Access Compliance Report

Public Rights-of-Way

(Pedestrian Signals)

Intersection ID: N/A	Main Street:	Cross Street: N/A	Location: N/A
ADA ID: E2F05ACDF959	Signal Type: Two Push Buttons-APS	Overall Compliance: No	Severity Score: BTN 1:N/A BTN 2: N/A No BTN: N/A
Codes/Mitigation Info/Possible Solution		Field Measurements/Component Compliance

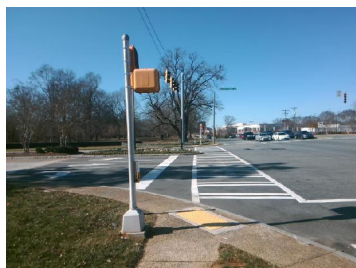
PROW/ADA: R410.6, TMUTCD 4e.08, R404.2, R404.3, R406.2, R209.1, R404.7.2

N/A B 1 Clear Xing Direction?	Yes	N/A B 2 Clear Xing Direction?	Yes
B 1 Crossing Direction	To NW	B 2 Crossing Direction	To NE
Yes B 1 DistanceTo XWalk (in)	30.0	Yes B 2 DistanceTo XWalk (in)	0.0
No B 1 DistanceTo Curb (in)	84.0	No B 2 DistanceTo Curb (in)	126.0
Yes B 1 Diameter (in)	2.0	Yes B 2 Diameter (in)	2.0

Possible Solutions: Replace Signal Push Button With APS Button on New Post. Remove & Replace Sign.
